IMPORTANT RECALL INFORMATION # 30908
September, 2003

SUBJECT: RECALL CAMPAIGN # 30908
2003 Model Year Pace Arrow, 2003 and 2004 Model Year Southwind and
Boulder built on Workhorse Chassis - Hydraulic Hose Routing

**SERVICE
BULLETIN:
#30908**

**SUBJECT:
Supporting the
Hydraulic Leveler
Hoses Above the
Rear of the
Engine**

Figure 1

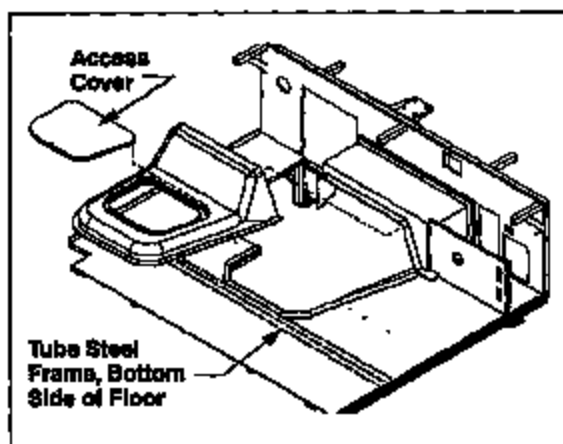
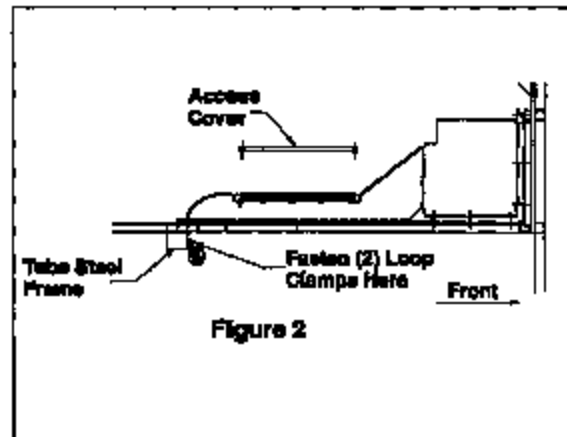
1. Retract all hydraulic levelers to the normal travel position.
2. Turn off the engine and remove the key from the ignition. Let the systems cool down (particularly the exhaust) before proceeding.
3. Remove the screws from the access cover built into the floor between the driver and passenger seats and lift out the cover. See Figures 1 and 2. The entire engine cover does not need to be removed.

3. Use two (2) insulated loop clamps #073725 to support the leveler hoses. Attach the insulated loop clamps with #8 X 1" Hex Head tec screws #004407 to the tube steel frame directly against the bottom side of the floor. Position the clamps to give the leveler hoses as much clearance as possible from hot engine components. See Figures 1 and 2.

Figure 3

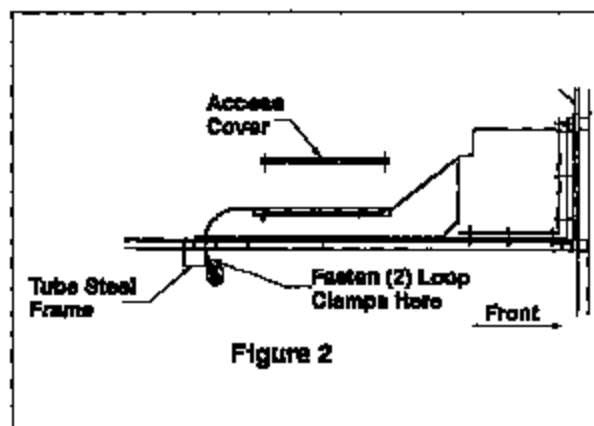
4. Look through the opening and slightly toward the rear of the motor home. Identify the two (2) hydraulic leveler hoses crossing from left to right. See Figure 3.
5. Carefully inspect the two (2) leveler hoses for heat related damage. Supplement the visual inspection by feeling the leveler hoses for damage. If the leveler hoses show signs of melting, are cracked, or are not flexible, they must be replaced.
